HDC

ADMINISTRATIVE APPROVALS

March 04, 2020

SH. 1

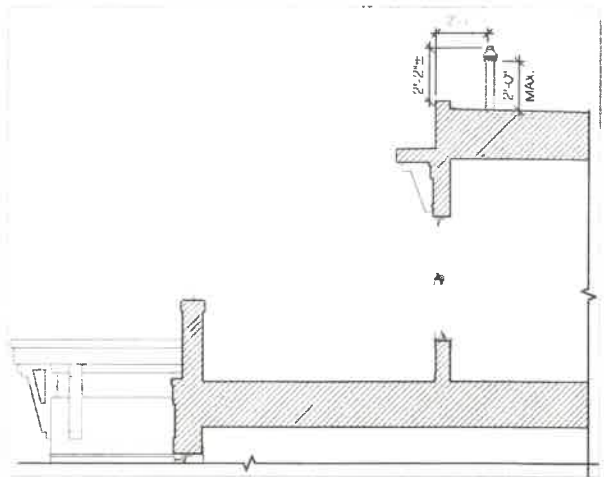
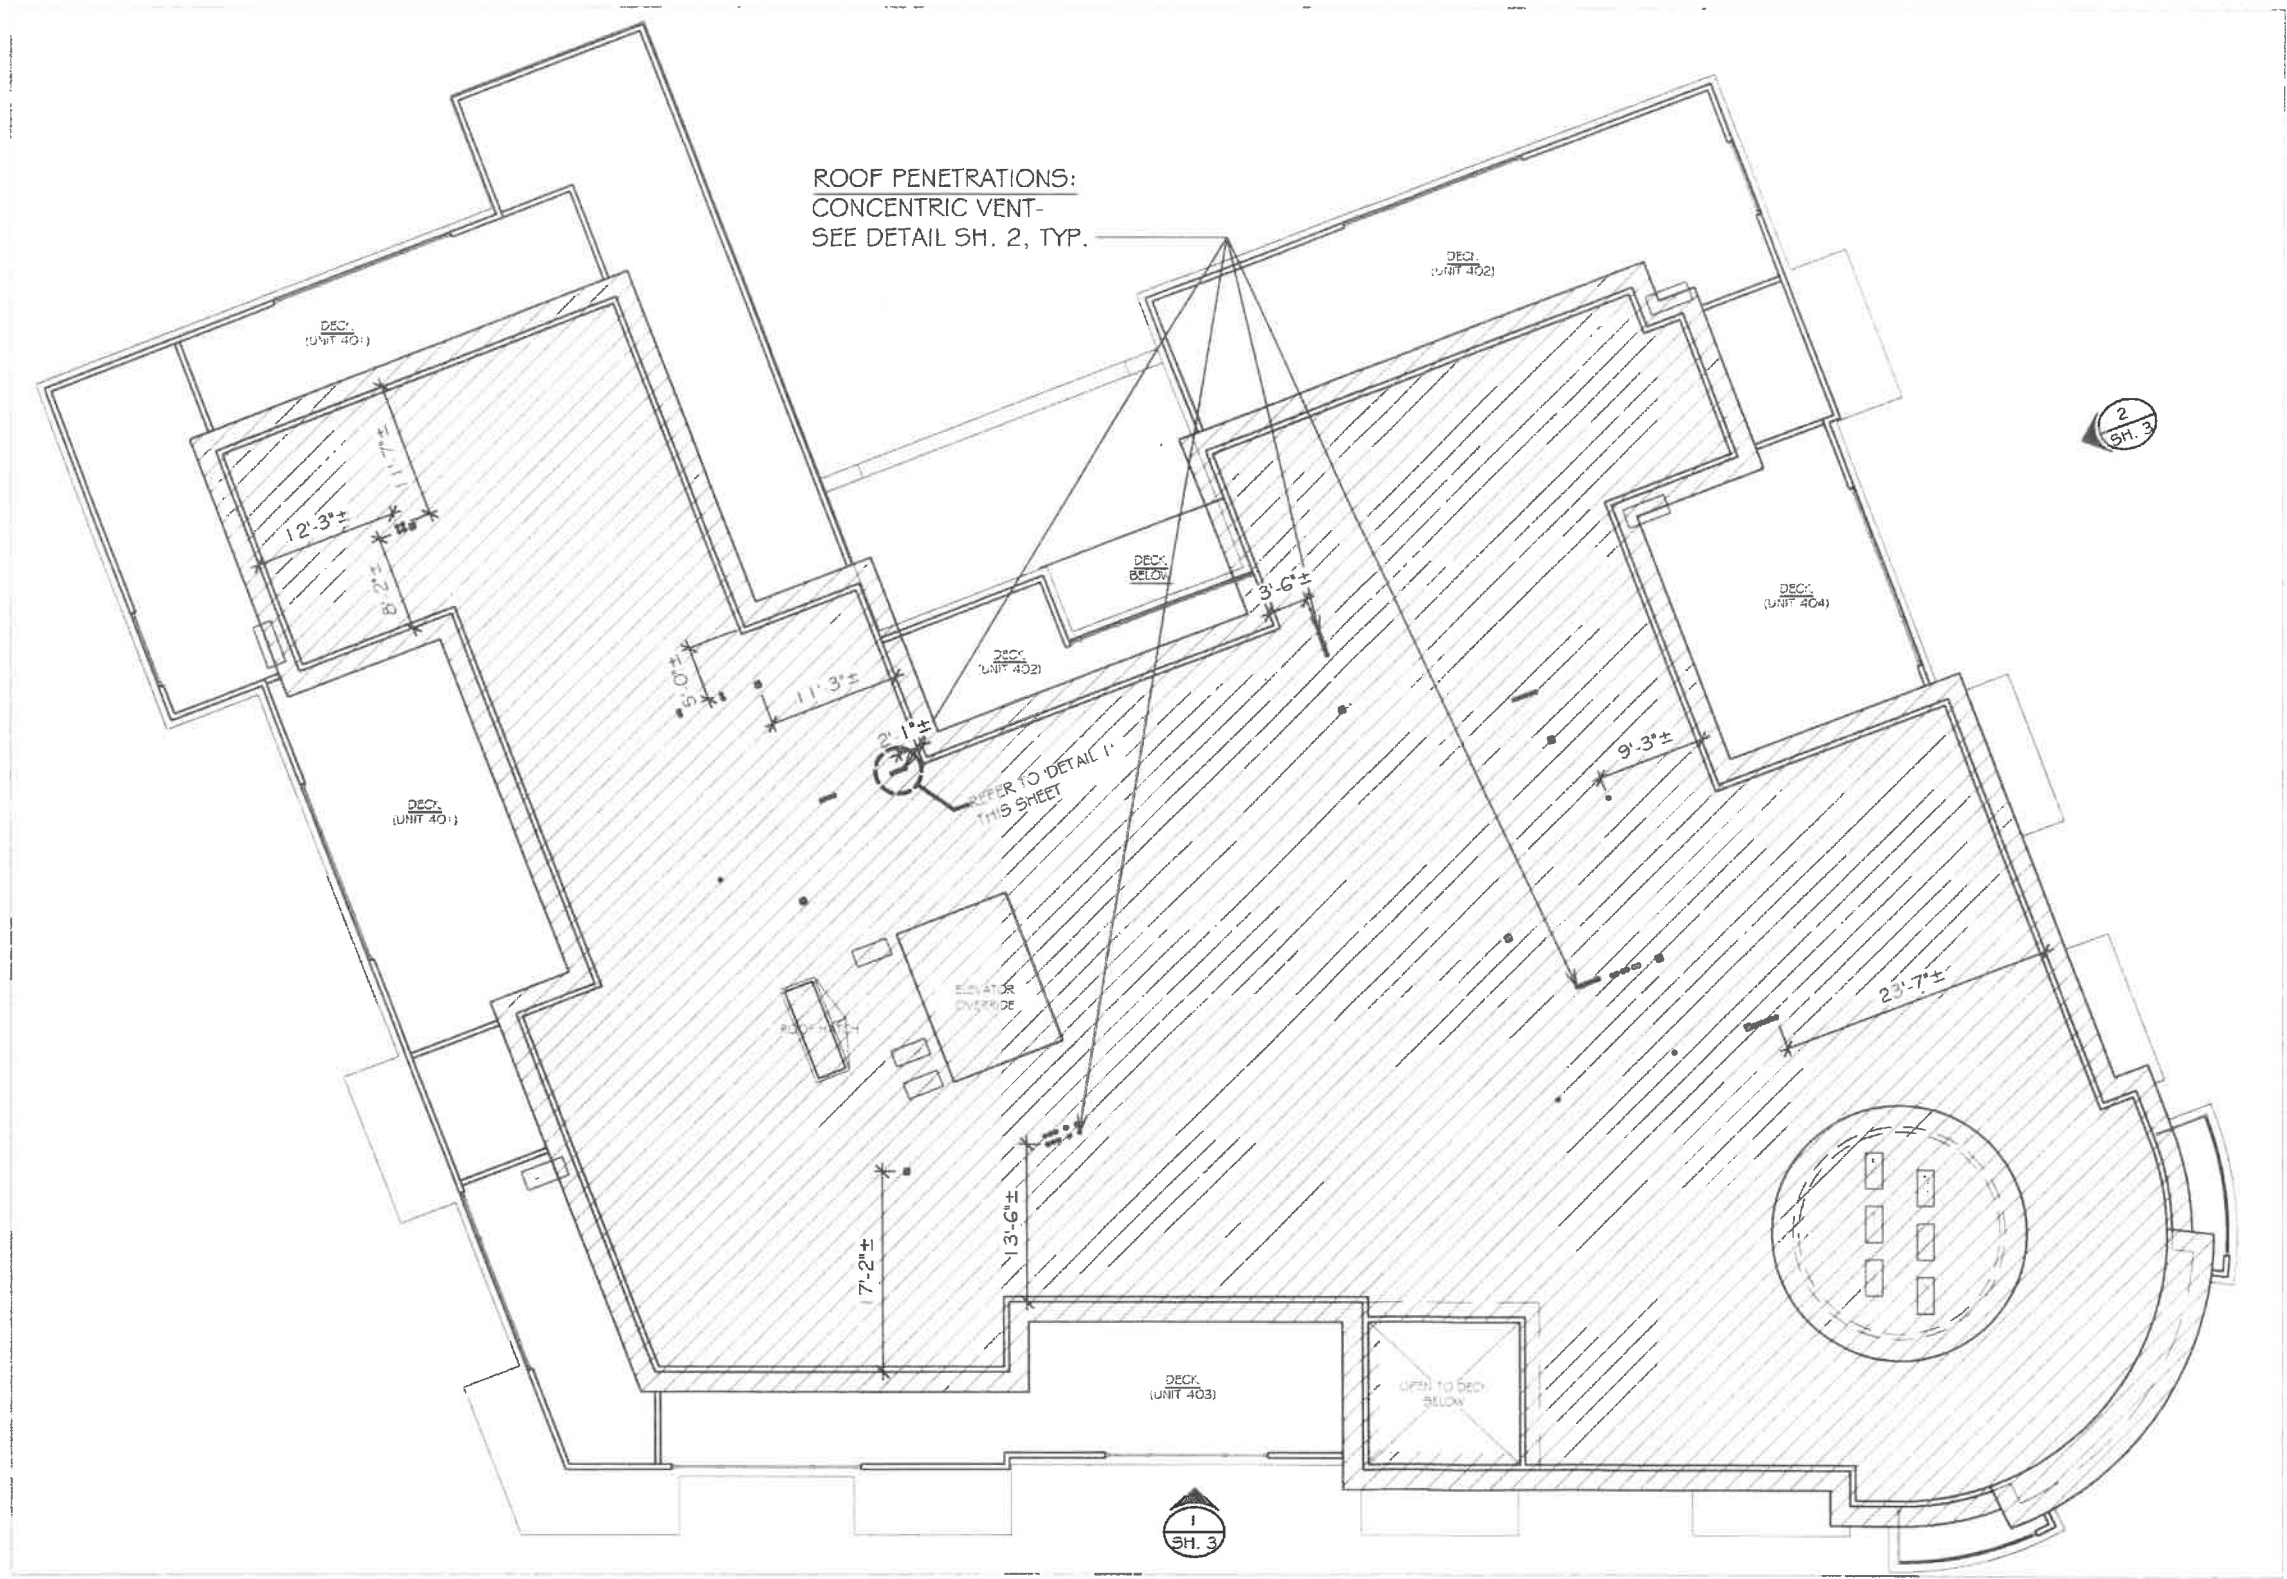
Background: The applicant is seeking approval for an amendment to a previously approved design (change mechanical vent locations, replace (2) doors with windows, and a new storefront assembly).

Previously Approved Roof Plan

SH. 2

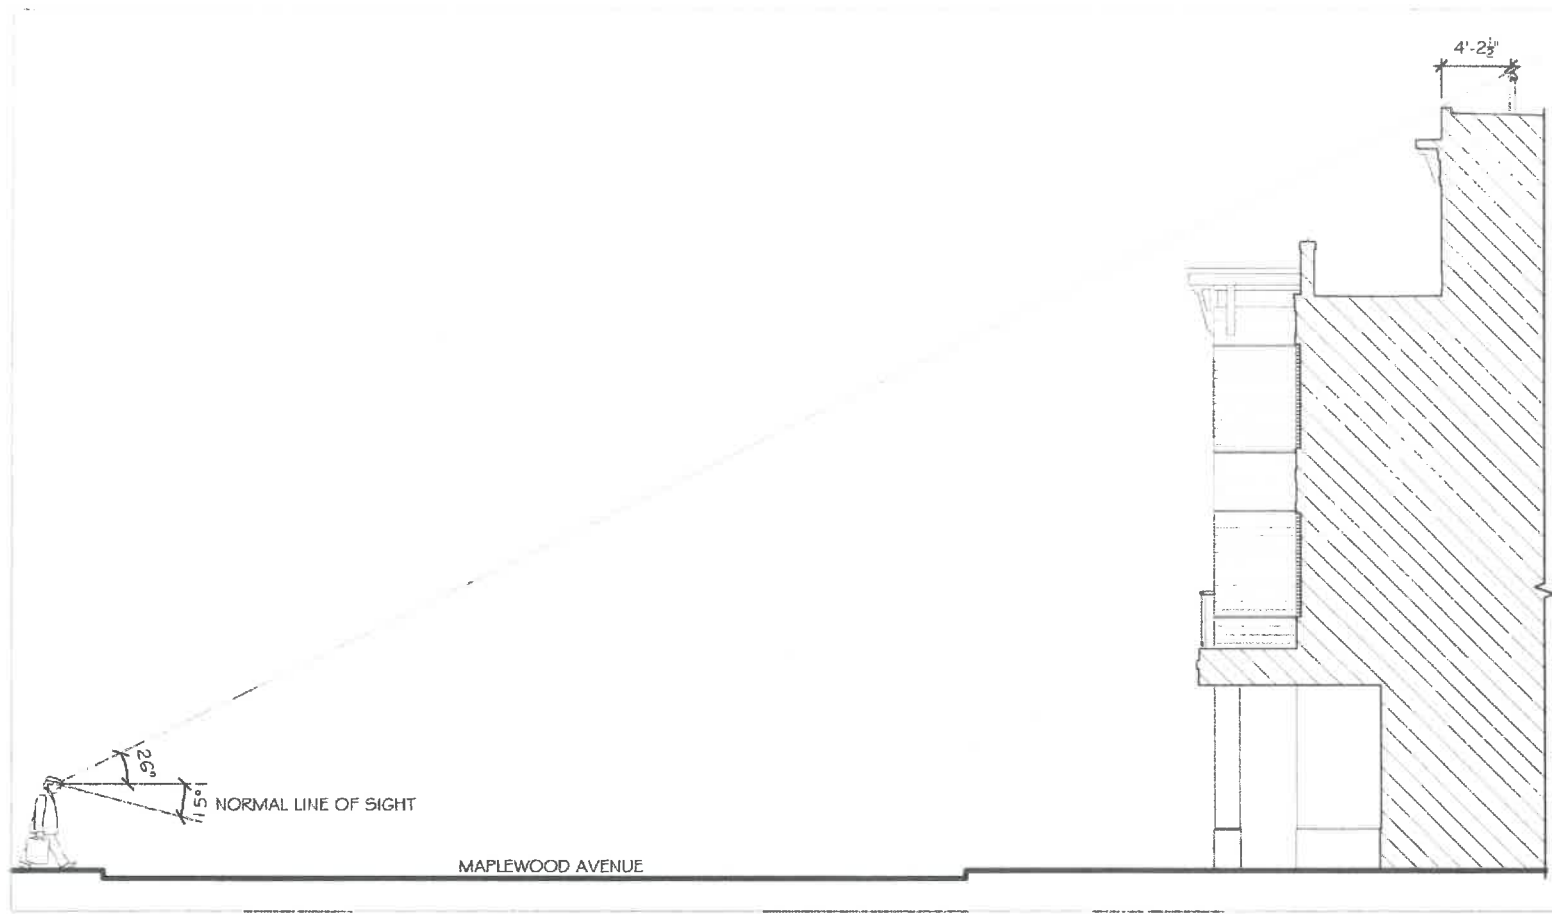
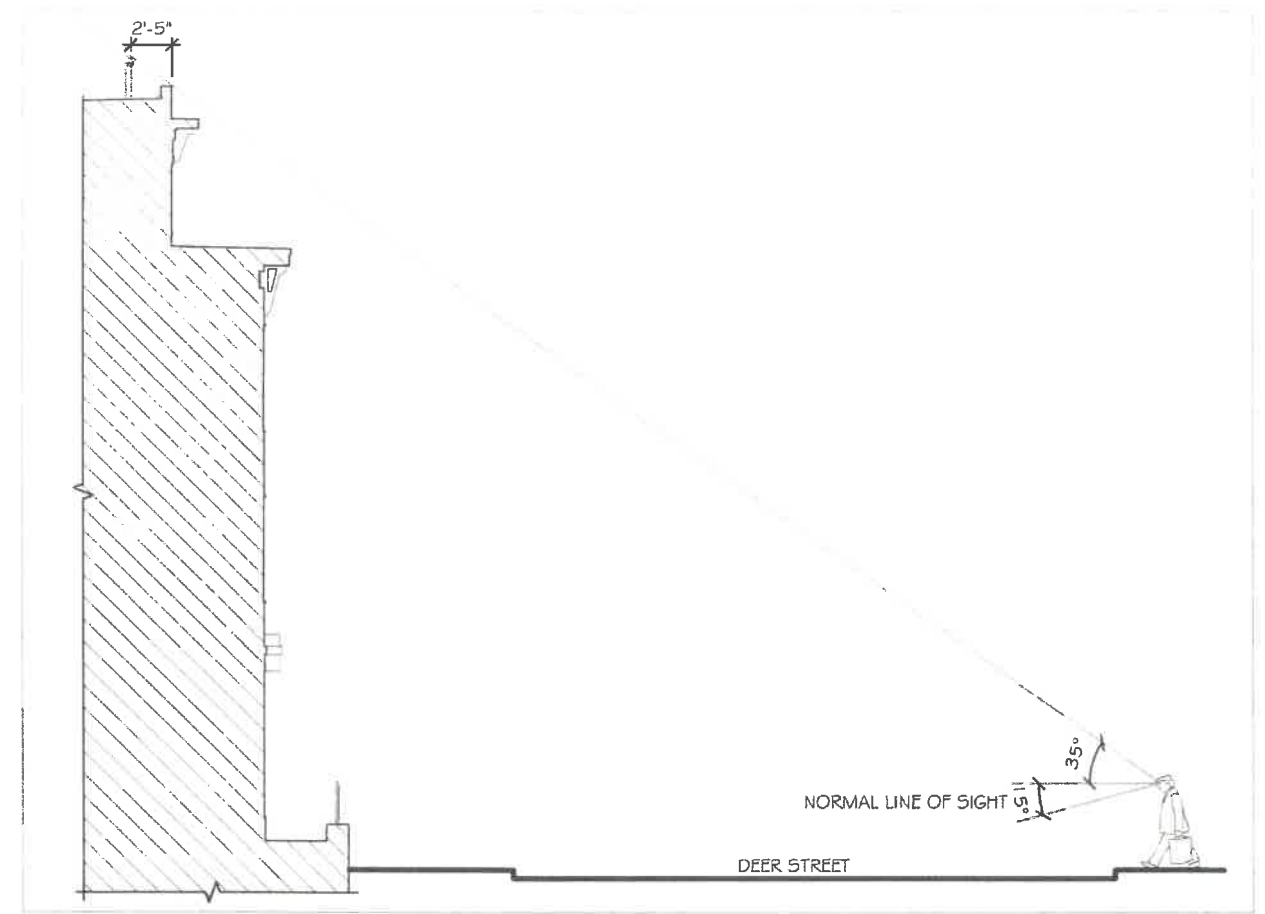
Proposed Roof Plan

1 **Rooftop Vent Views: Maplewood Avenue**
SCALE: Not to Scale

2 **Rooftop Vent Views: Deer Street**
SCALE: Not to Scale

SH. 7

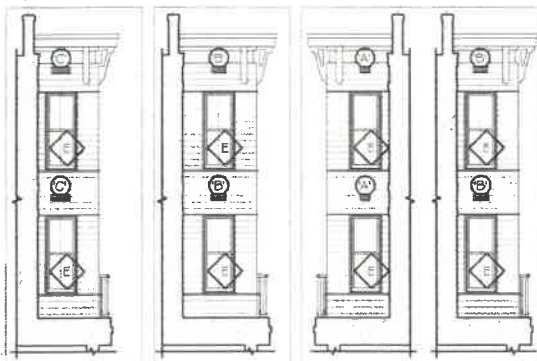
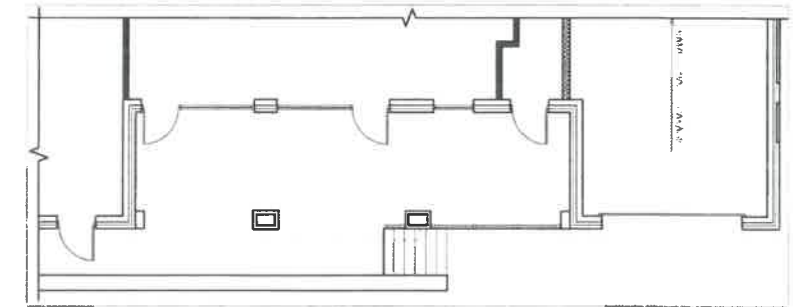
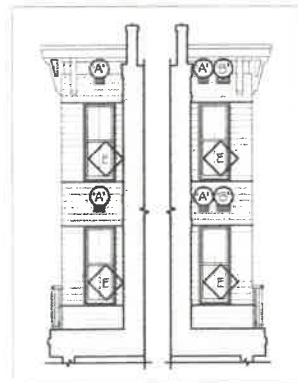
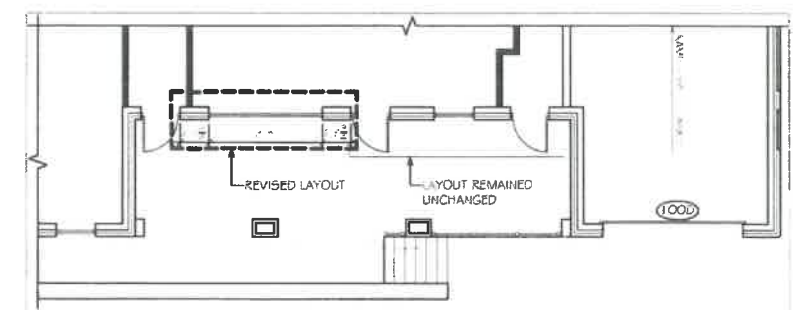
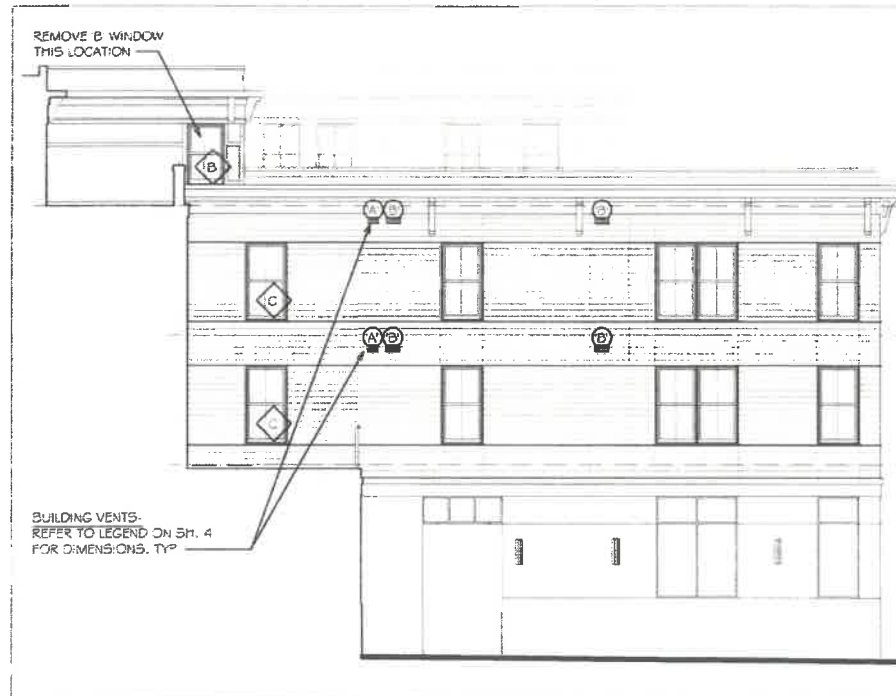
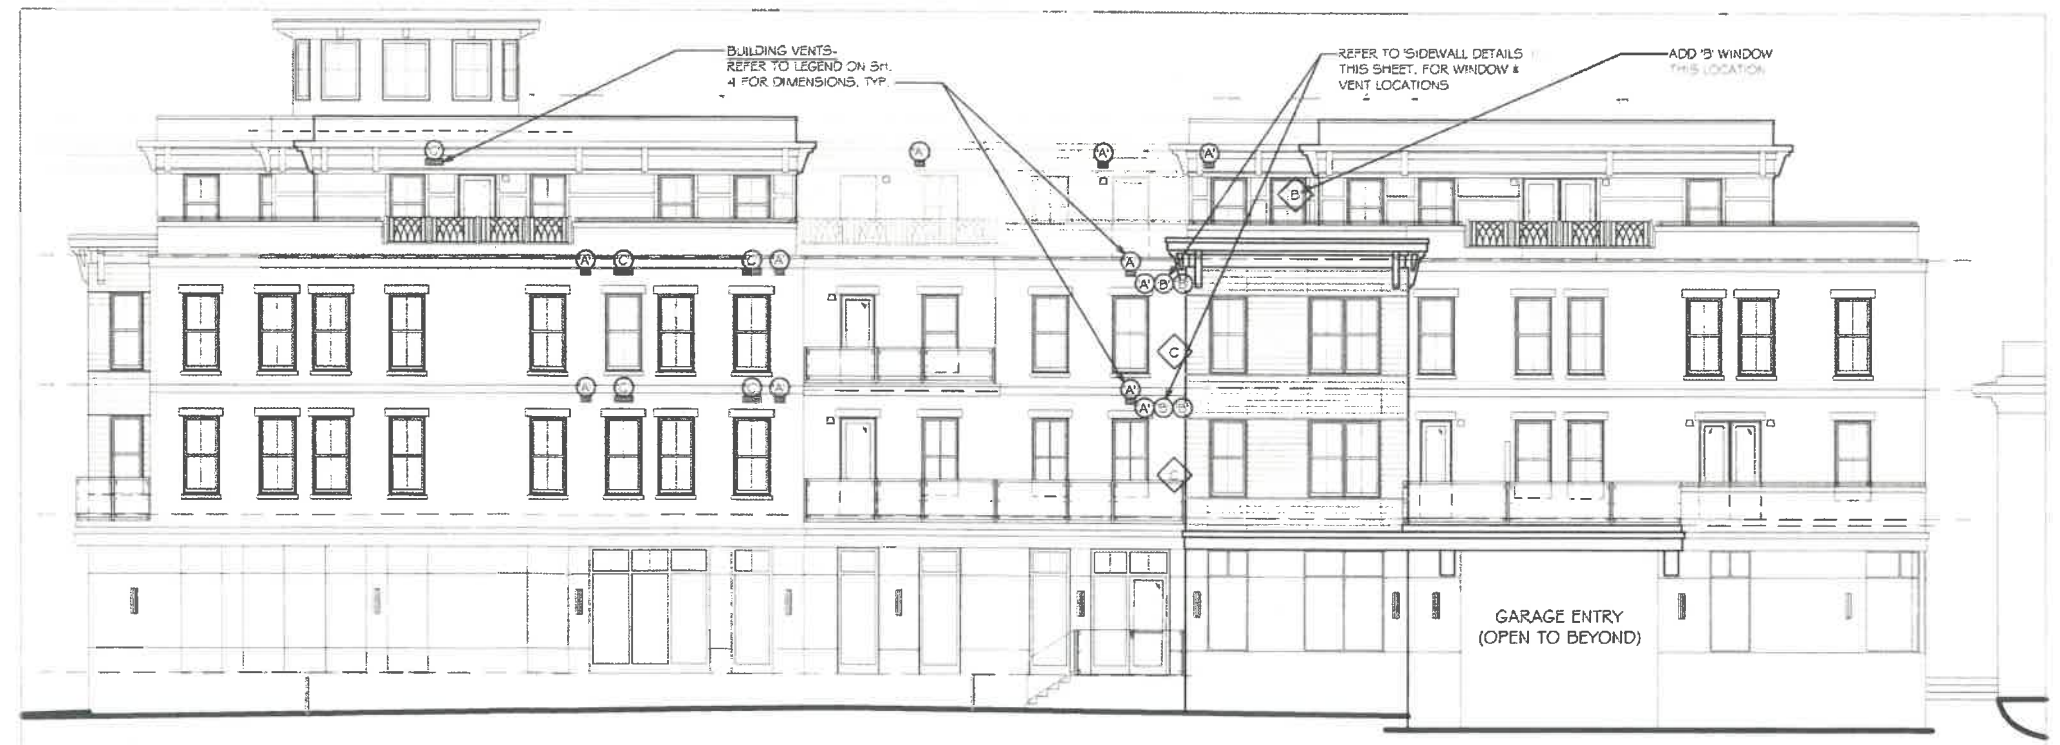
Previously Approved Maplewood Avenue Elevation
SCALE: N.T.S.

Proposed Maplewood Avenue Elevation
SCALE: N.T.S.

Previously Approved Deer Street Storefront
SCALE: N.T.S.

Proposed Deer Street Storefront
SCALE: N.T.S.

Proposed Bridge Street Elevation
SCALE: N.T.S.
